**ZONING AMENDMENT,  
& SUBDIVISION STAFF REPORT****Date: February 21, 2008**

<b><u>APPLICANT NAME</u></b>	Pang Swee-Chin
<b><u>SUBDIVISION NAME</u></b>	Swee Subdivision
<b><u>LOCATION</u></b>	Southeast corner of Cottage Hill Road and Dogwood Court
<b><u>CITY COUNCIL DISTRICT</u></b>	District 4
<b><u>PRESENT ZONING</u></b>	R-1, Single-Family Residential District
<b><u>PROPOSED ZONING</u></b>	B-2, Neighborhood Business District
<b><u>AREA OF PROPERTY</u></b>	1 Lot / 2.9 ± Acres
<b><u>CONTEMPLATED USE</u></b>	Subdivision approval to create 1 lot, and Zoning approval to rezone the site from R-1, Single-Family Residential, to B-2, Neighborhood Business, to allow a restaurant. It should be noted, however, that any use permitted in the proposed district would be allowed at this location if the zoning is changed. Furthermore, the Planning Commission may consider zoning classifications other than that sought by the applicant for this property.
<b><u>REASON FOR REZONING</u></b>	Applicant is requesting rezoning of the site to allow a restaurant.

# SITE PLAN

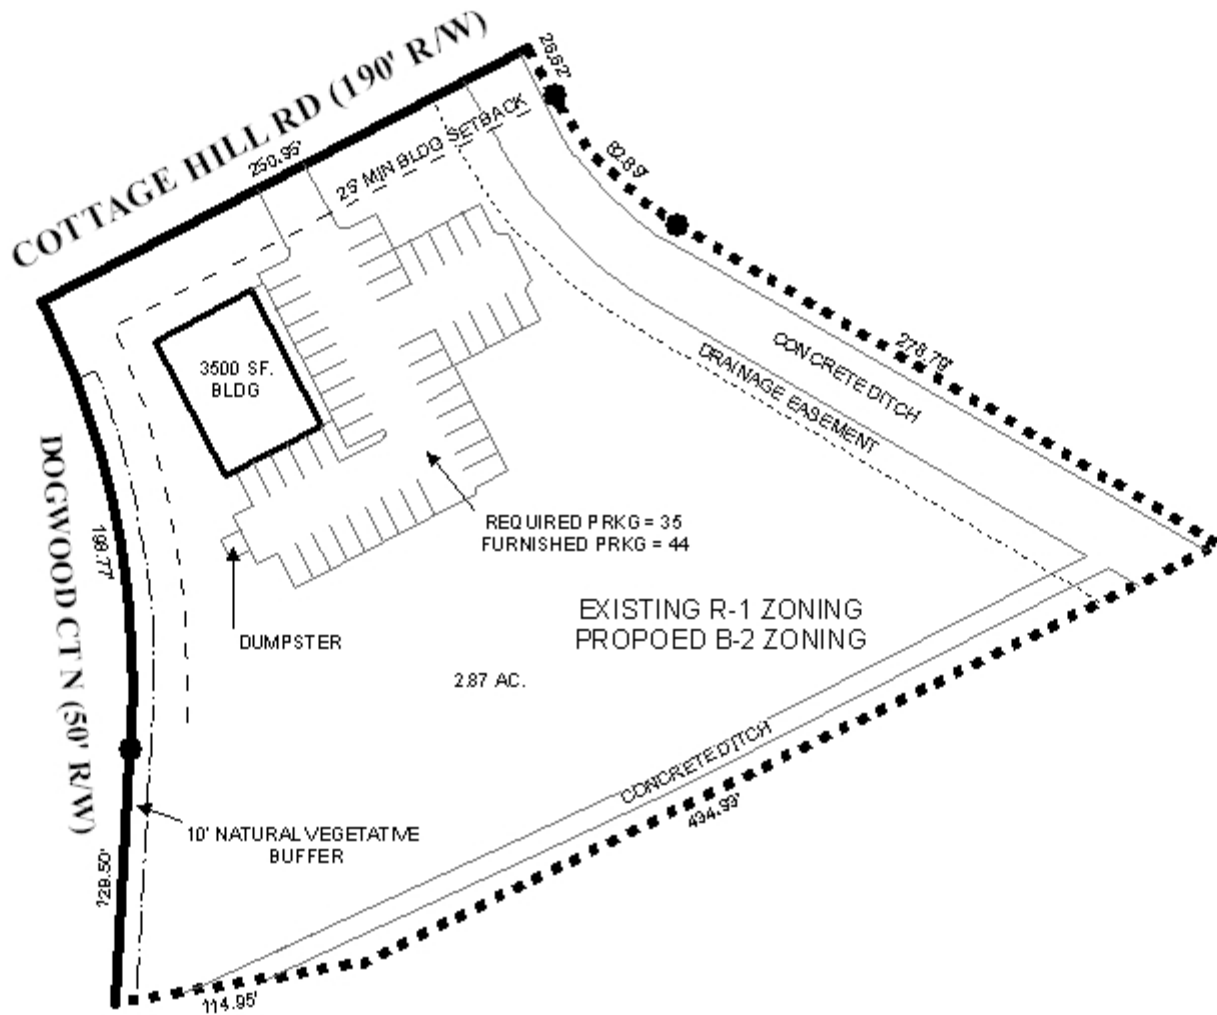
As the site is a corner lot with frontage on a major street and minor, residential street, access management is a concern. The site plan submitted with the Zoning application depicts one curb-cut onto Cottage Hill Road and no curb-cuts onto Dogwood Court North. It is recommended that the site be limited to one curb-cut onto Cottage Hill Road, and denied access to Dogwood Court North, with the size, design and location to be approved by Traffic Engineering and conform to AASHTO standards.

Development of the site must comply with the requirements of the Zoning Ordinance in order to minimize negative impacts to adjacent residential development. Buffers and control of site lighting should be provided, as required by the Zoning Ordinance. The depicted 10-foot natural buffer proposed along Dogwood Court North by the applicant may not be adequate to provide much in the way of actual buffering, so it is recommended that buffer be widened to 20-feet and left in a natural state, or augmented with additional plantings to ensure buffering between the site and residences to the West.

The depicted parking lot layout does not appear to provide optimal circulation, and may in fact increase the possibility of traffic accidents within the parking area due to poor design. Redesign of the parking area is recommended prior to the applicant applying for commercial site plan review.
